SEWAGE DISPOSAL SYSTEM

MARYLAND STATE DEPARTMENT OF HEALTH

A REPAIR

ADDRESS 799 Driver Road, Marriottsville, Maryland 21104 PHONE 442-1708

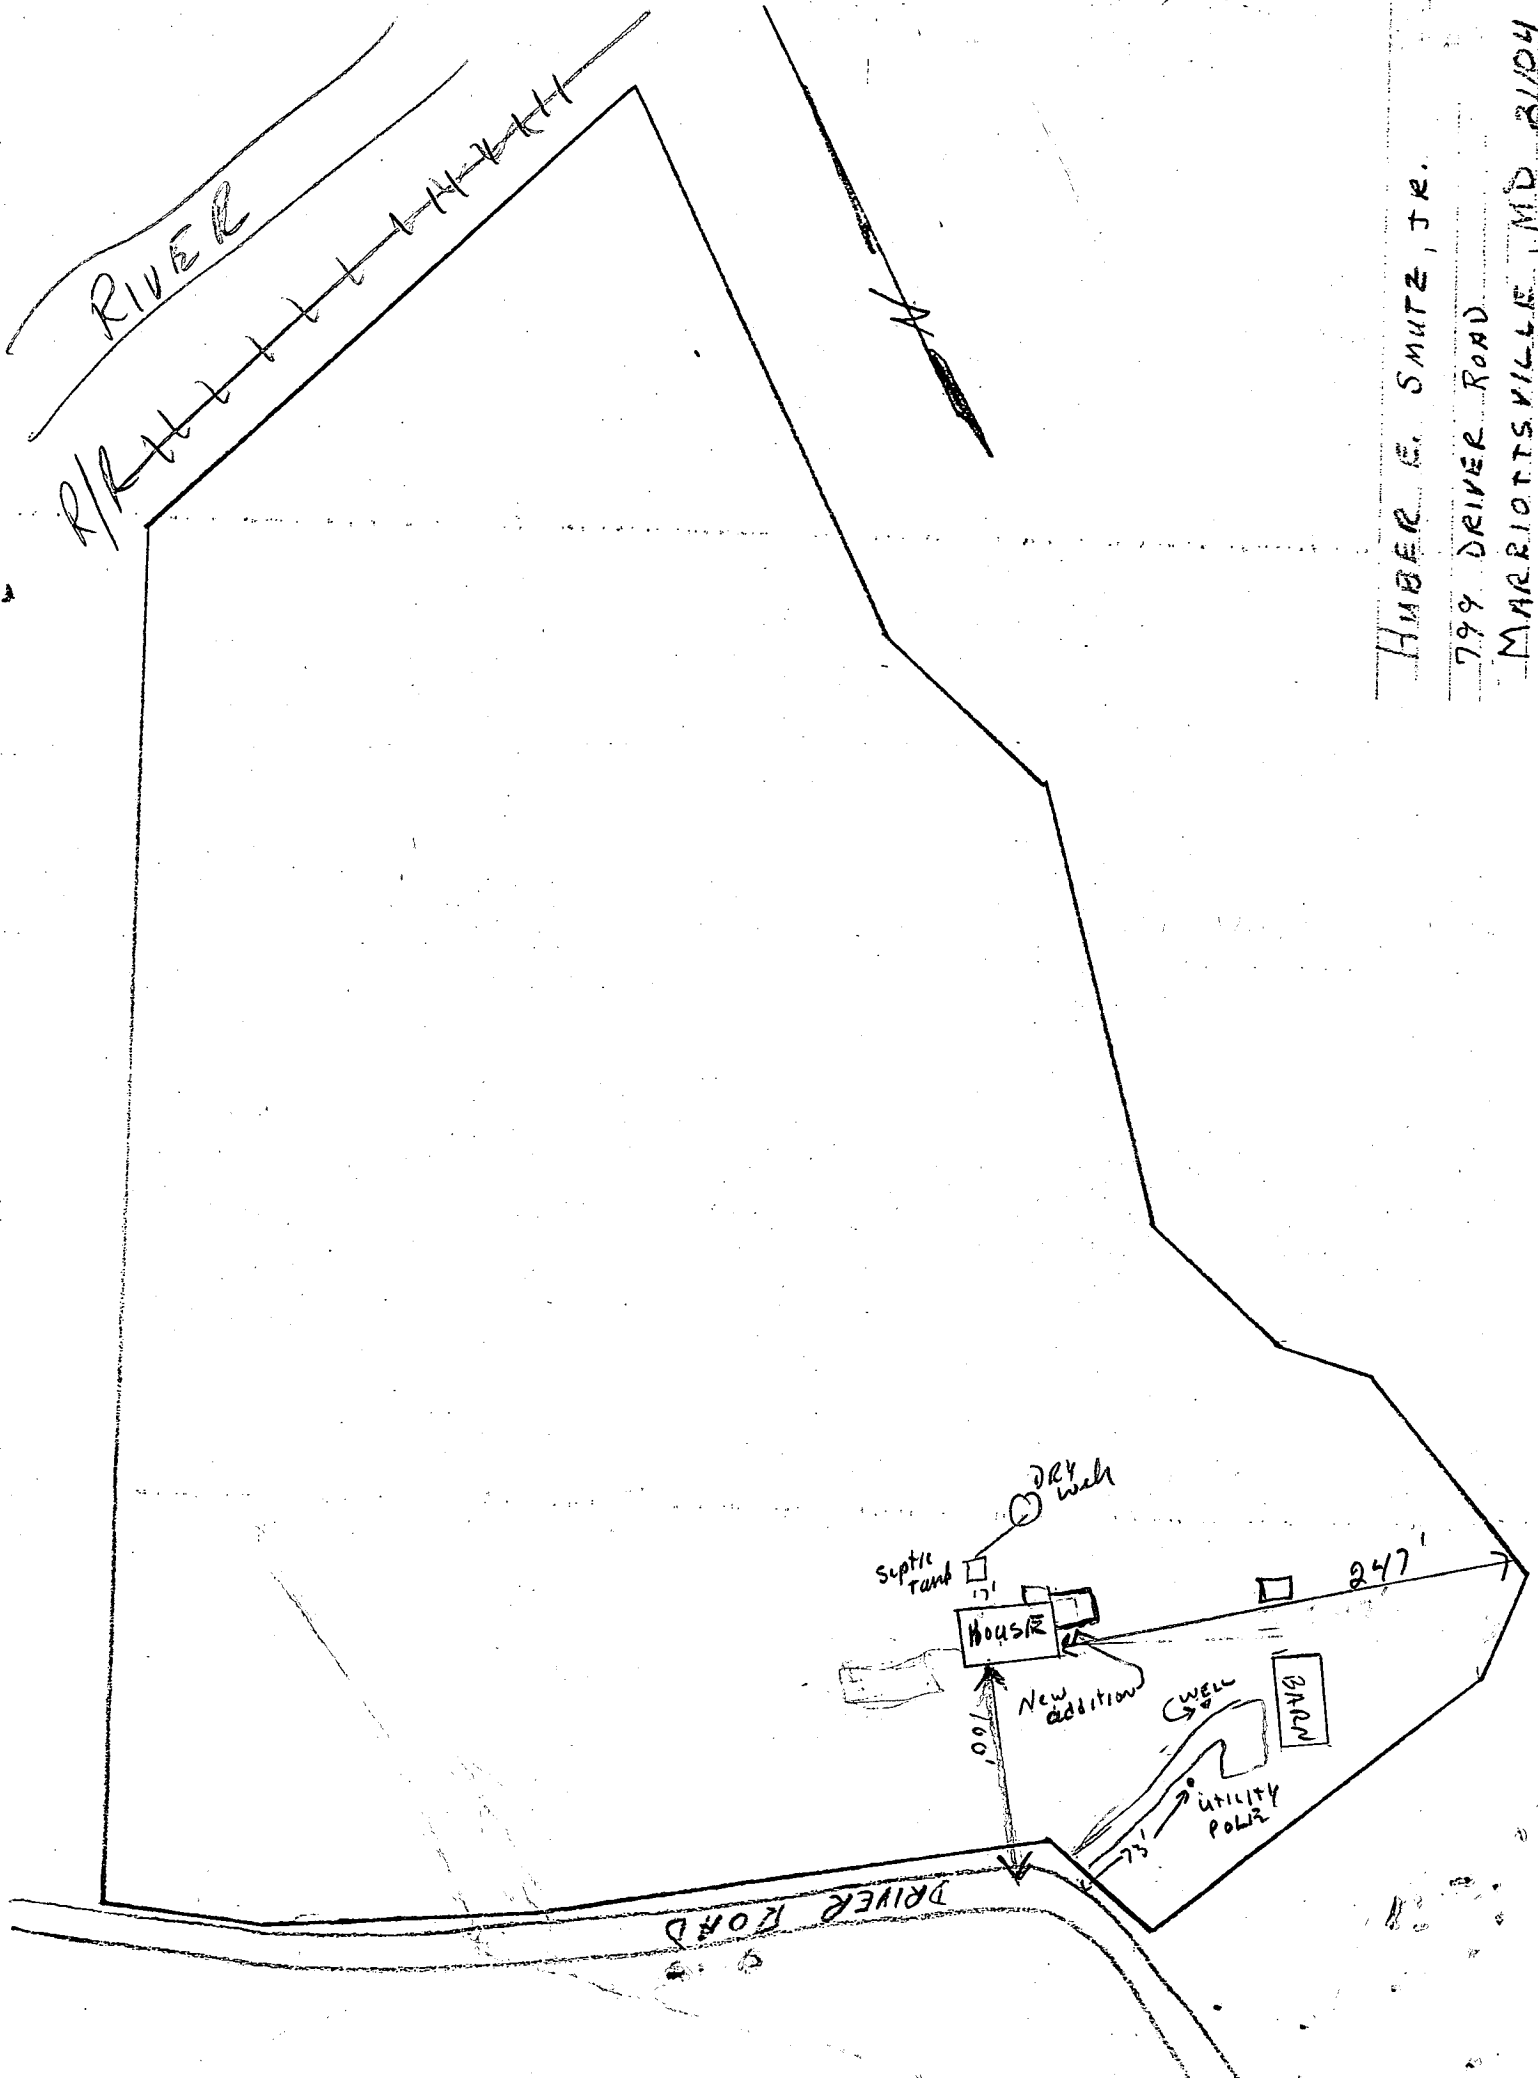
REMARKS SYSTEM INSTALLED 1985 WITHOUT PERMITS OR INSPECTION.

PROPERTY OWNER PRODUCED PHOTOS OF INSTALLATION FEB 24, 1989.

PHOTO'S + MEASUREMENTS REVIEWED OK - REPAIR FEE PAID.

OWNER RECEIVES VERBAL REPRIMAND FOR INSTALLATION WITHOUT PERMIT.

NO PURPOSE SERVED BY DIGGING UP SYSTEM - SYSTEM APPROVED.

LOCATION DIAGRAM

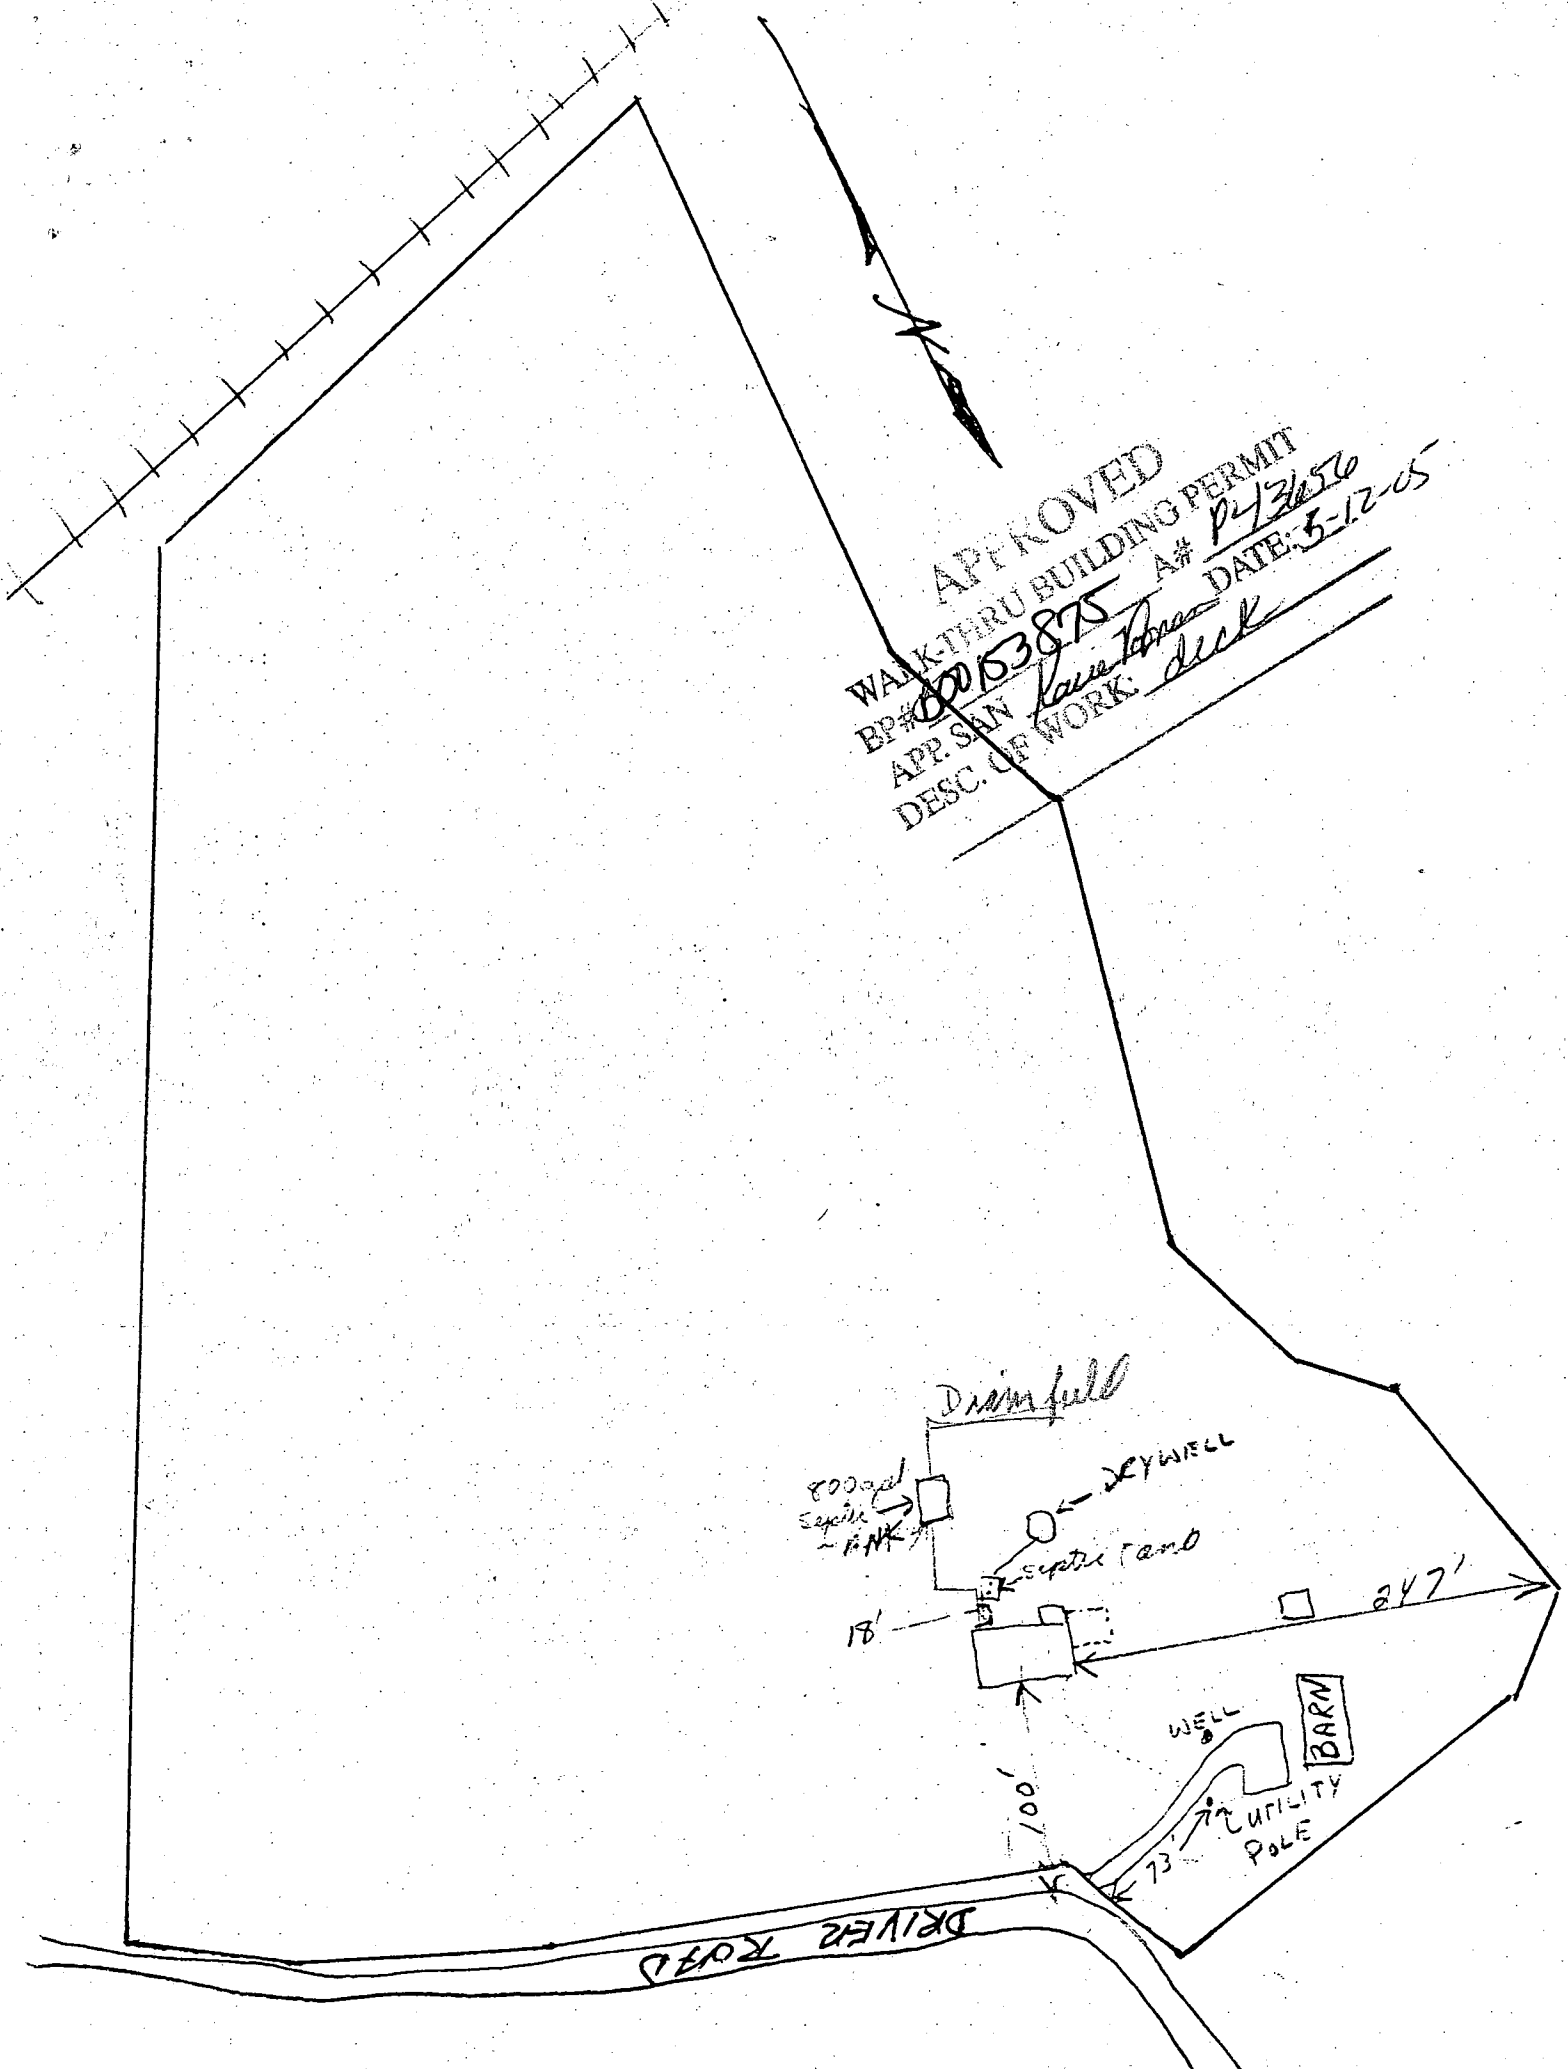
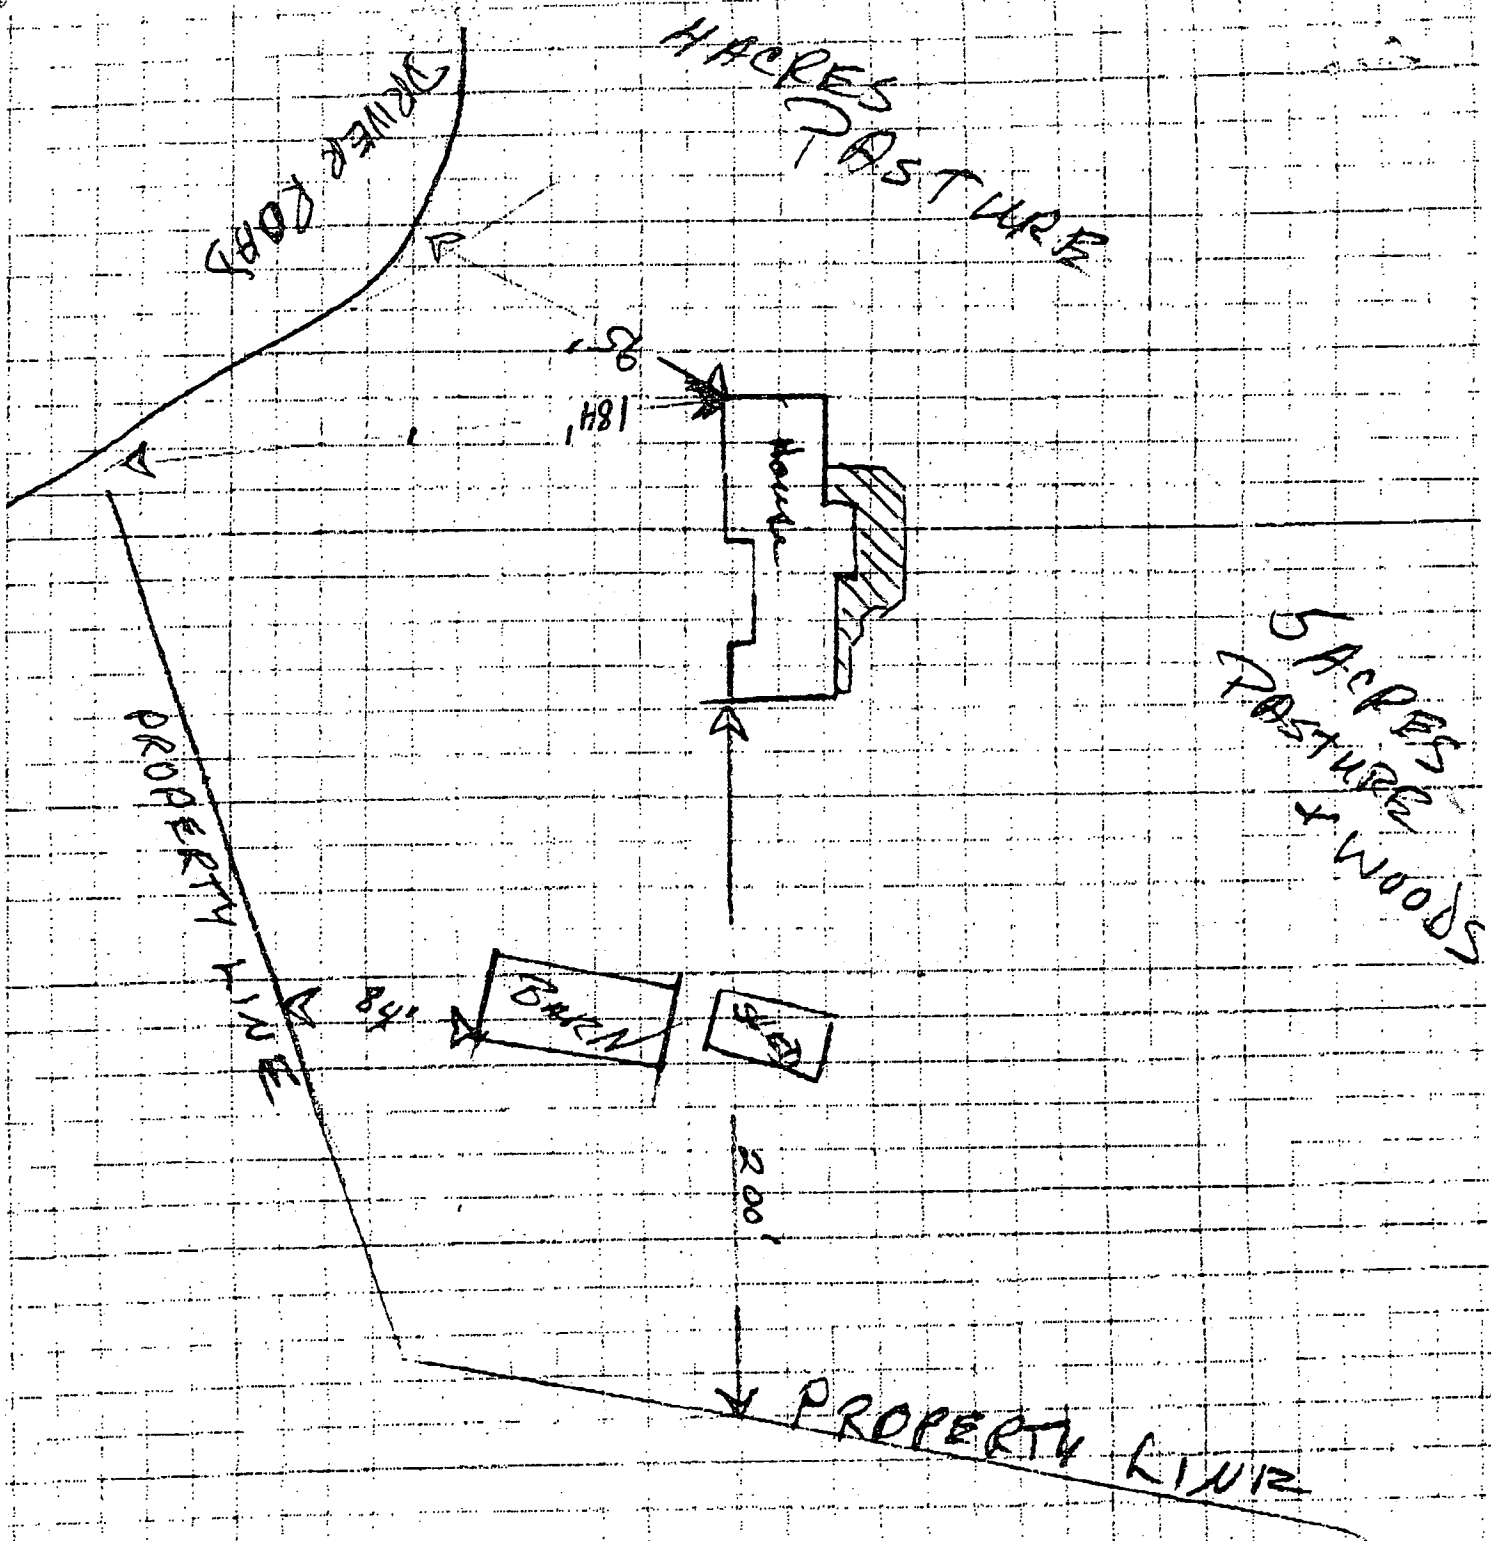
COMMENTS: top of tank (1) is ~ 1' - 2.5' from surface. top tank (2)
is ~ 1' from surface. Both tanks are > 10' away from
proposed deck addition.
